Bulletin Number - BP3 Promenade - Bulletin 08

Project	Steamboat Base Village Redevelopment	Date	08/06/2021
Project Location	Steamboat, Colorado	Architect's Project Number	03.7835.000
Owner/Client	Alterra Mountain Company / East West Partners	File	6BL This is page 1 of 2
To	Saunders Construction Inc.	Attention	Bryan Sculthorpe
Address	86 Inverness Place North		
City	Englewood	State	CO Zip Code 80112
Delivered via:	<input type="checkbox"/> Messenger <input type="checkbox"/> Hand carried <input type="checkbox"/> Facsimile <input type="checkbox"/> Express <input type="checkbox"/> Pick-up <input type="checkbox"/> E-mail Address <input type="checkbox"/> Mail <input type="checkbox"/> UPS <input checked="" type="checkbox"/> Website Address BIM360

Description of Changes

1A-E1.000

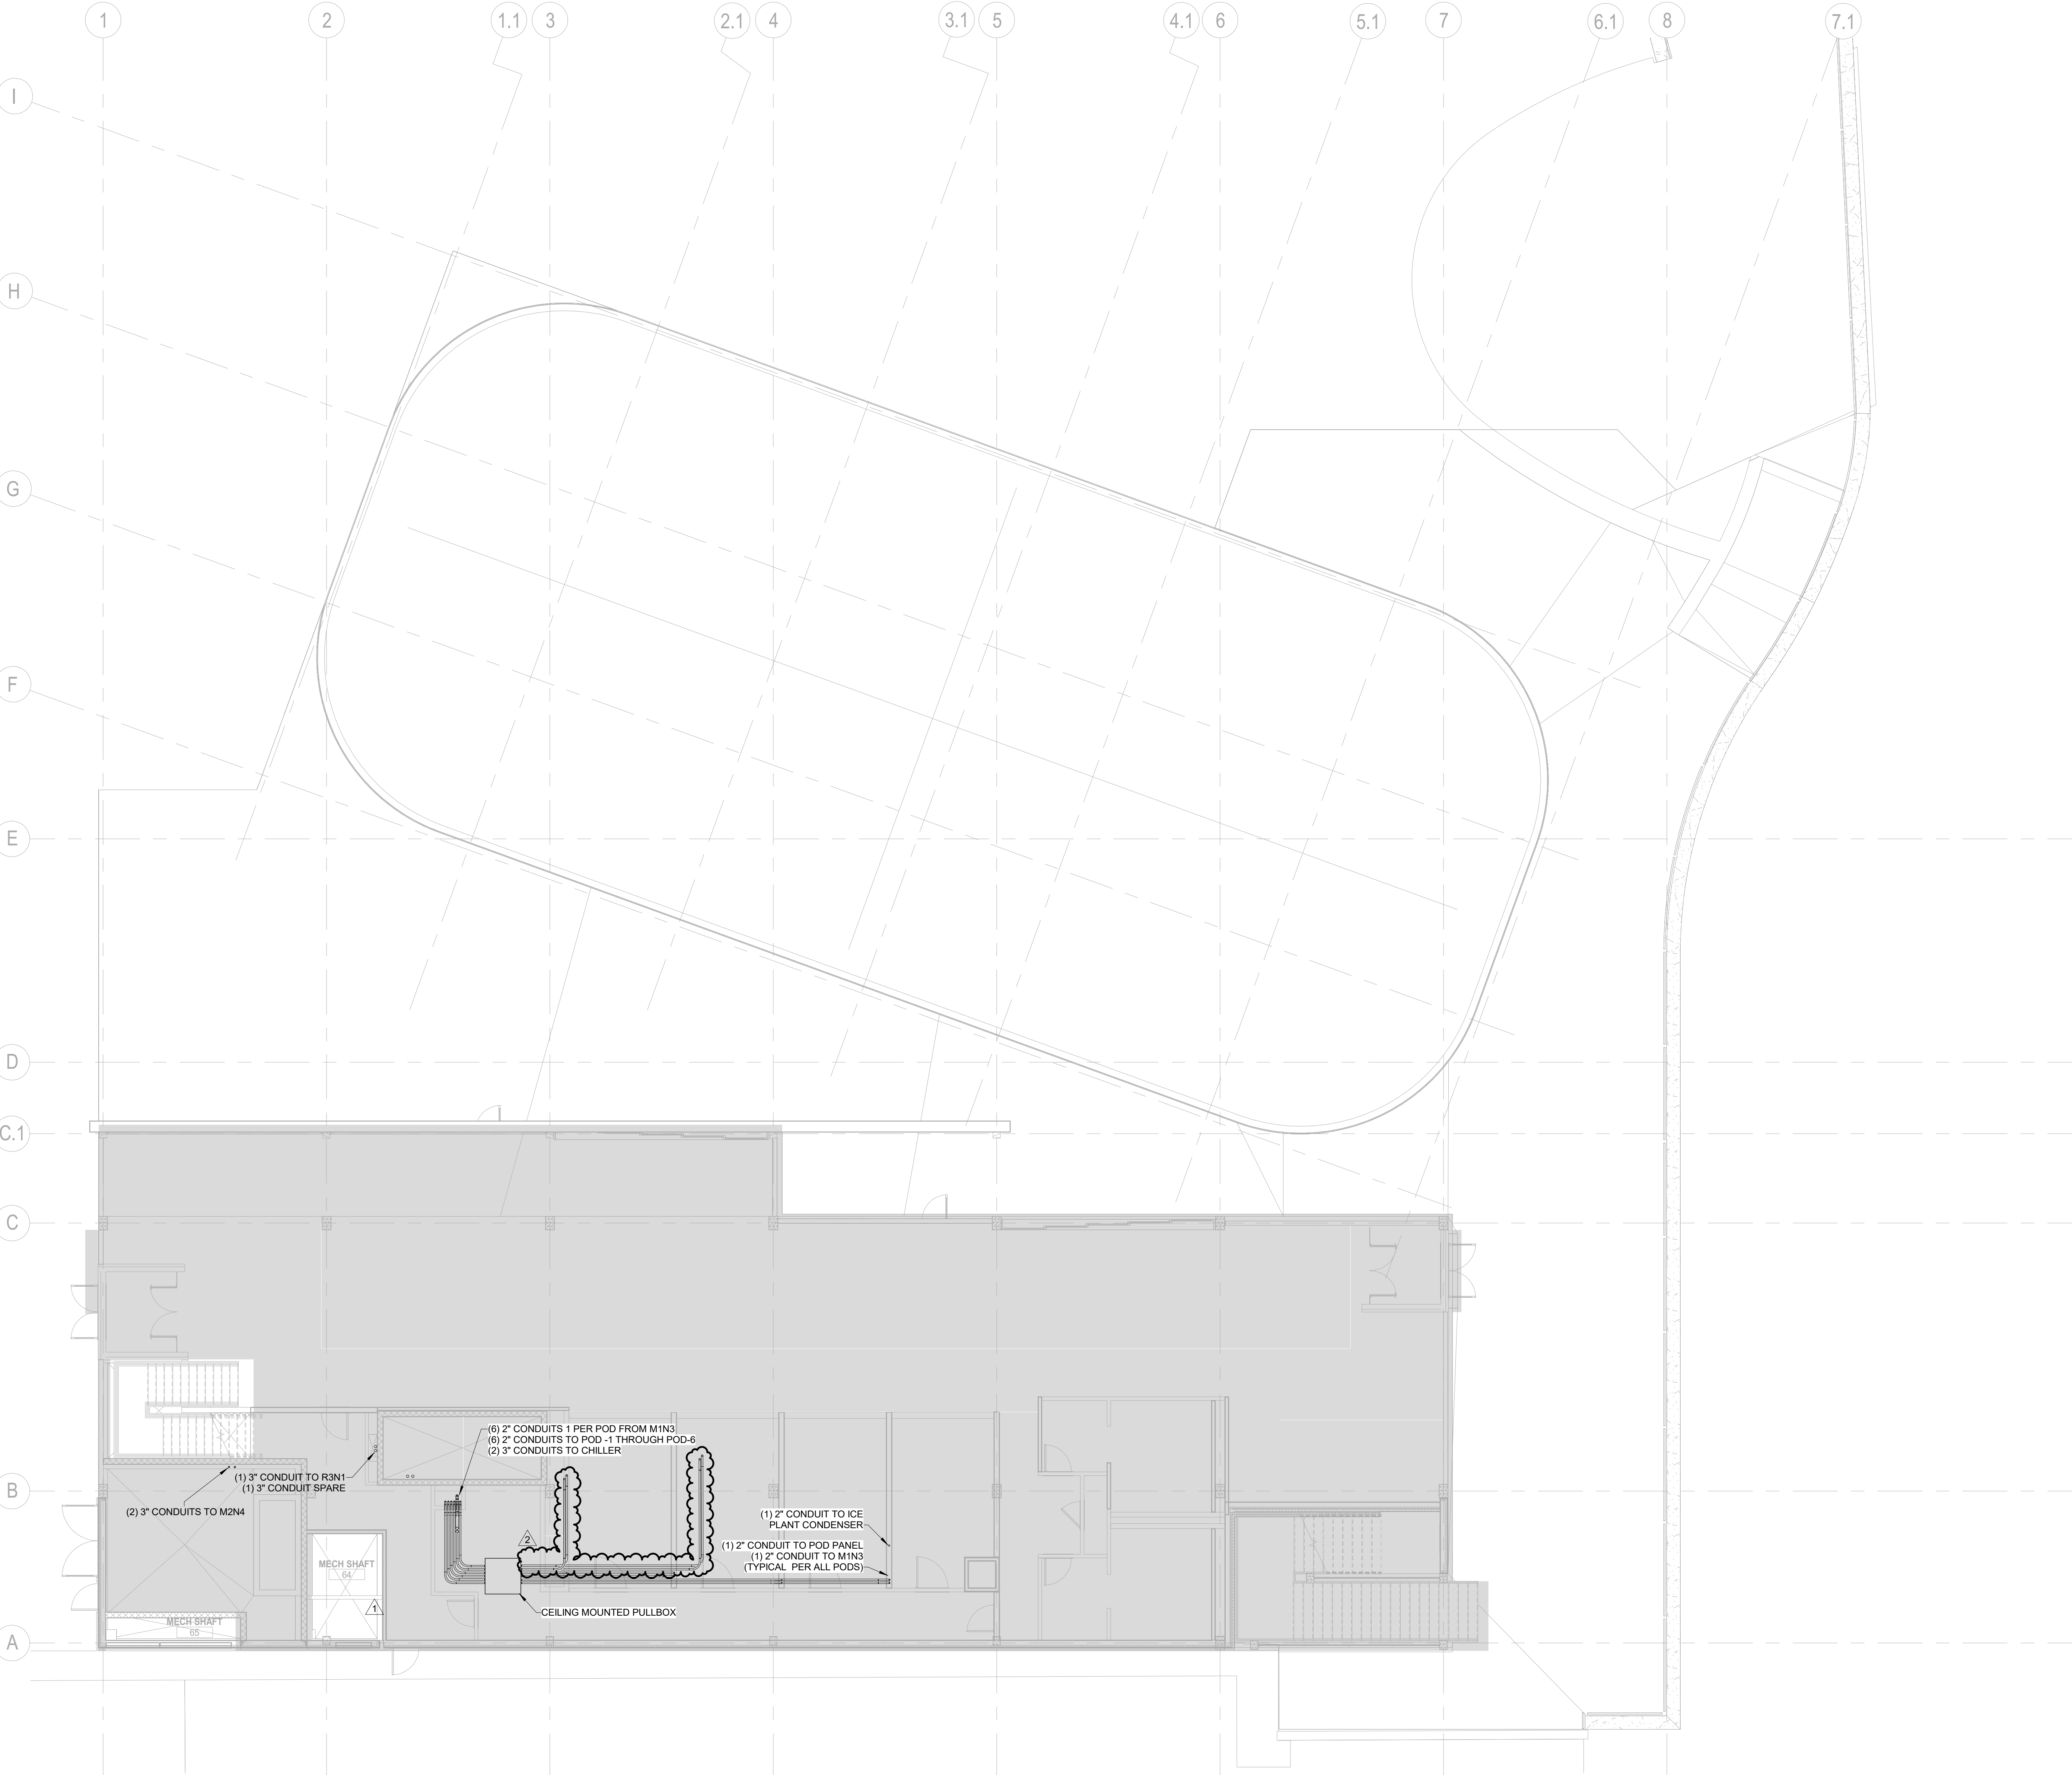
- 21. 1A-E1.000
 - a. Modified circuiting for pedestal electrical connections to be 50A/2P in lieu of 50A/3P.
 - b. Modified circuiting to align with site lighting changes.

- c. Added Site receptacle for added trees adjacent to stage building.
- 22. 1A-E1.101
 - a. Added conduit routing for future phase 2 POD-5 and POD-6 panels.

1A-E1.200

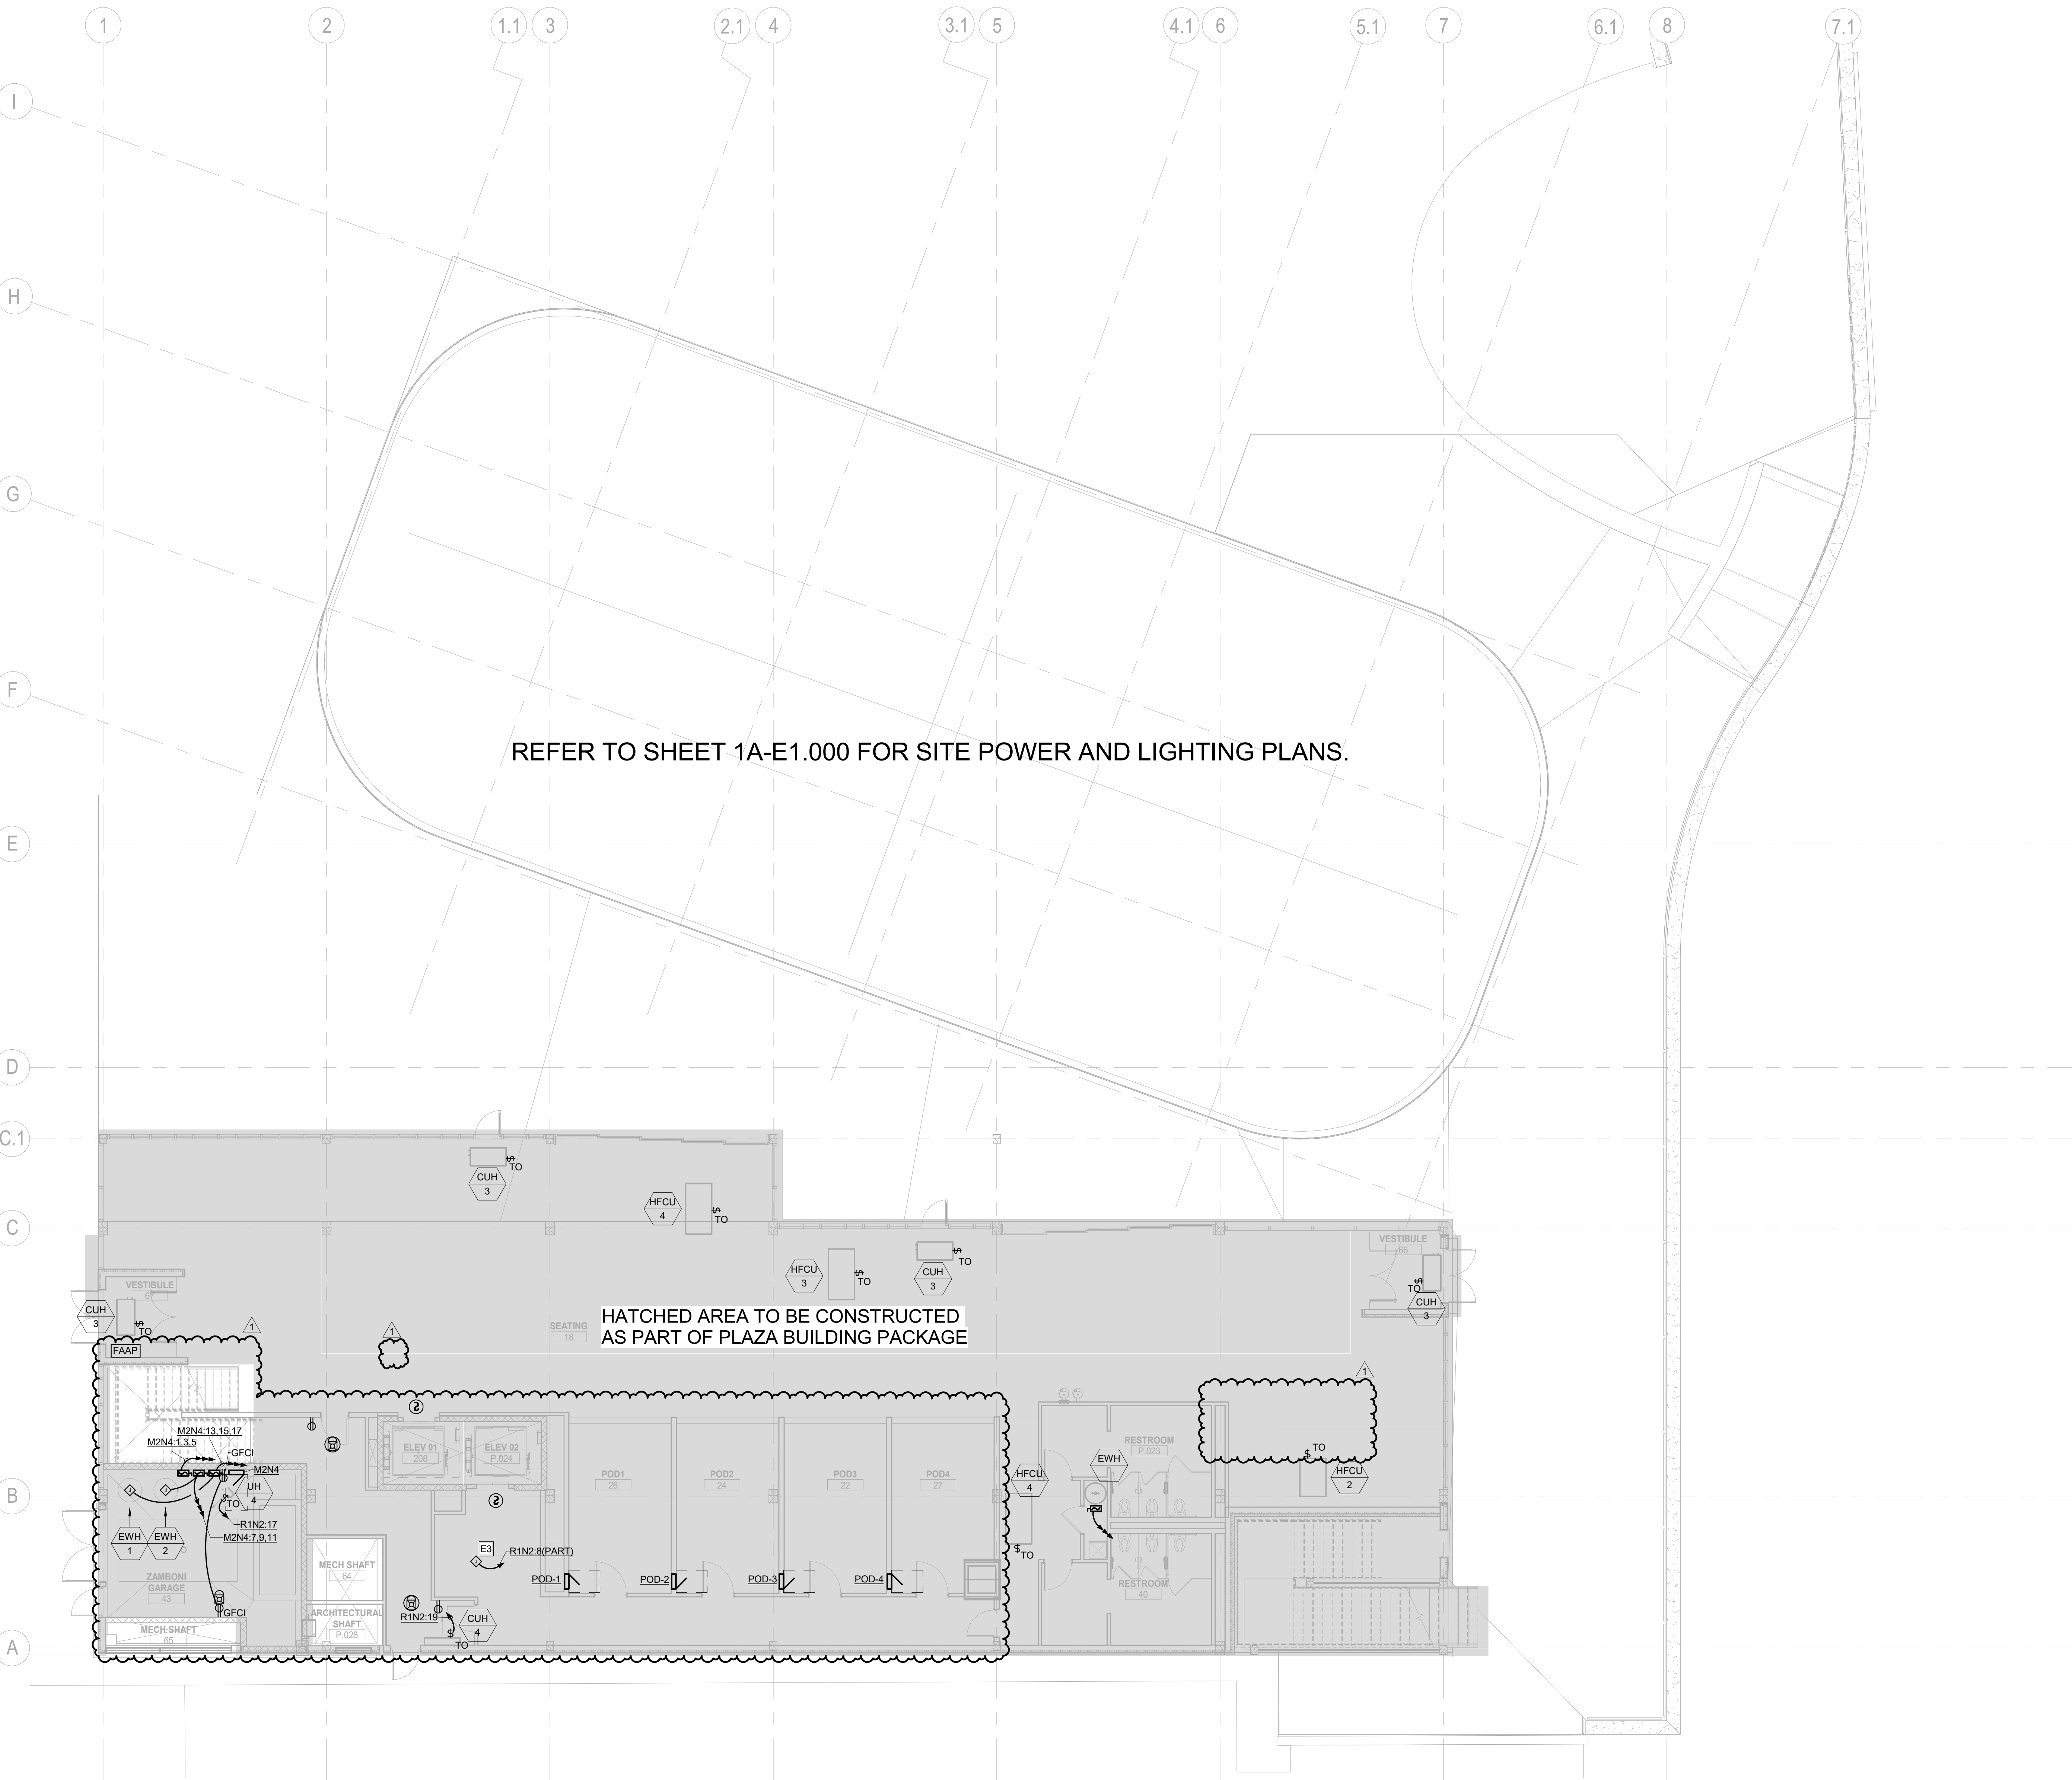
- 23. 1A-E1.102
 - a. Added conduit routing for future phase 2 POD-5 and POD-6 panels.
- 24. 1A-E1.200
 - a. Modified electrical device layout, fire alarm device layout, and branch circuiting per plaza and promenade building redesign.

- b. Modified scope in gray hatch for clarity. Per conversations with Architect, any and all scope behind the gray hatch is not included in phase 1 scope of work in the field.
